HISTORIC AND DESIGN REVIEW COMMISSION

January 6, 2017

HDRC CASE NO: 2016-488
ADDRESS: 215 CLAUDIA ST
LEGAL DESCRIPTION: NCB 2876 BLK 1 LOT 7
ZONING: RM-4,H
CITY COUNCIL DIST.: 1
DISTRICT: King William Historic District
APPLICANT: Ricardo McCullough
OWNER: Vidal Gonzalez
REQUEST:

A REMODEL AND ADDITION

LEFT ELEVATION
SCALE: 3/16" = 1'-0"

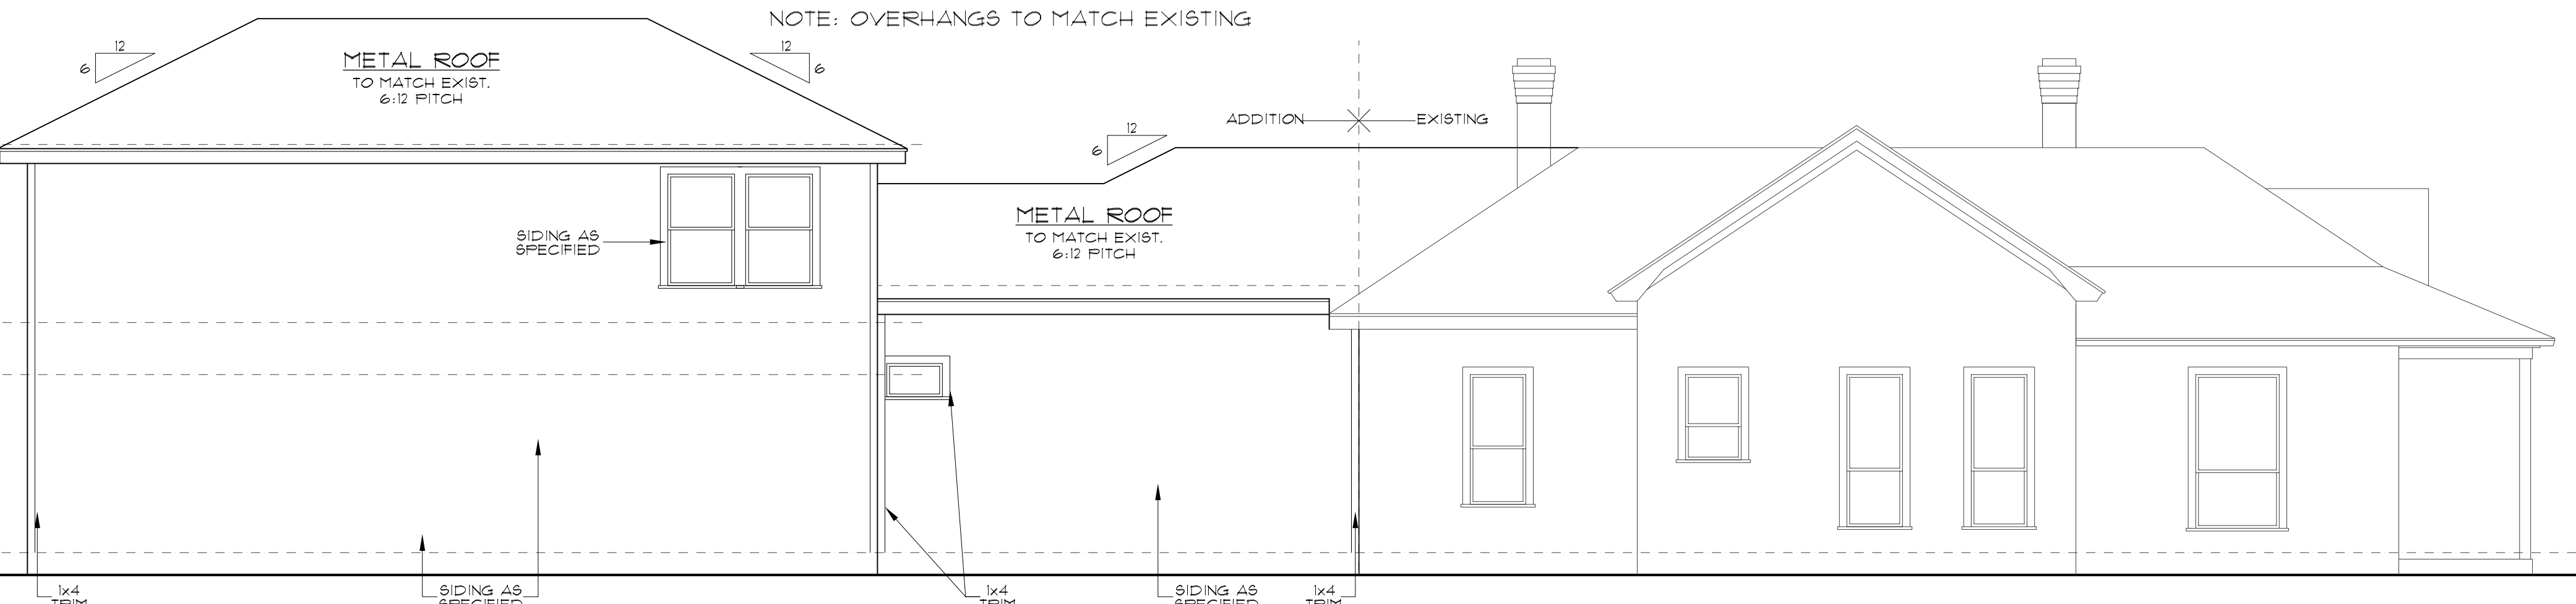
- i. ADDITION FENESTRATION – The applicant has provided elevations of the proposed addition that feature a left façade that features only one small window opening. The Guidelines for Additions 4.A.i. states that the shapes of window opening should relate to those of the primary historic structure. Staff finds that the applicant should propose additional fenestration on this façade.

LINE OF SIGHT

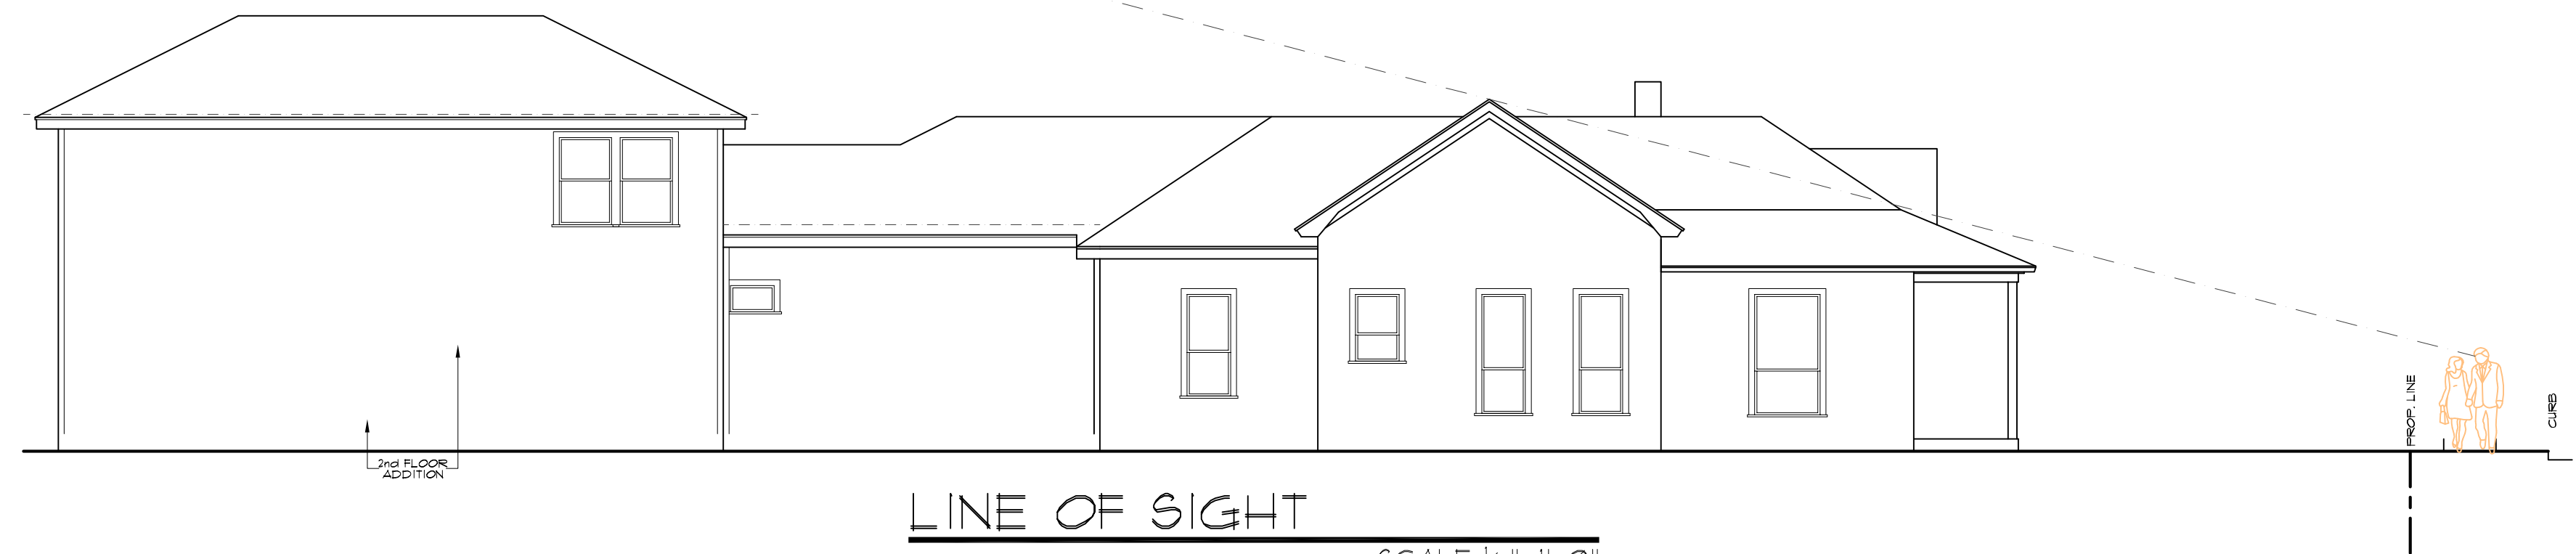
- g. TWO STORY SECTION – At the rear of the primary historic structure and attached to the single story portion of the proposed addition, the applicant has proposed to construct a rear two story addition that is to feature a ground level garage to provide parking for three vehicles and a second level that is to house a dwelling unit. The Guidelines for Additions 1.A. states that additions should be sited to minimize visual impact from the public right of way. Additionally, the Guidelines note that residential additions should be in keeping with the existing, historic context of the block. This block of Claudia features approximately twelve primary historic structures, of which only one features two stories. Staff finds the applicant's proposed two story addition is not consistent with the Guidelines. The applicant has provided a line of sight study noting the impact of the structure's height from the public right of way.
